Access Compliance Report Public Rights-of-Way (Curb Ramps)

Main Street: MARTHA_ANN_DR Cross Street: SALMON_DR Location: NE

ADA ID: RPRK211216112537 Ramp Type: Type 1 - Perpendicular Diagonal Initial Pass/Fail: Pass Overall Compliance: No Severity Score: 22

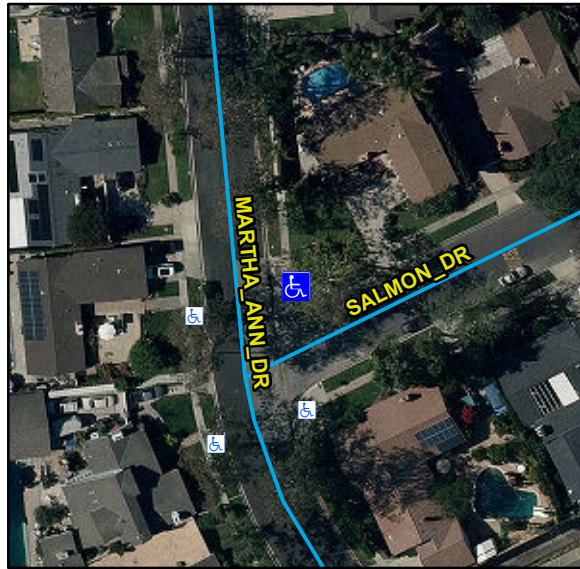
Remove & Replace Curb Ramp With Two New Directional Ramps or Equivalent. Grind Gutter Lip.

R204.3, R304.2.1, R304.2.2-Perp, R304.3.2-Para, R304.5.3, R305, R302.7.2, STD 1115
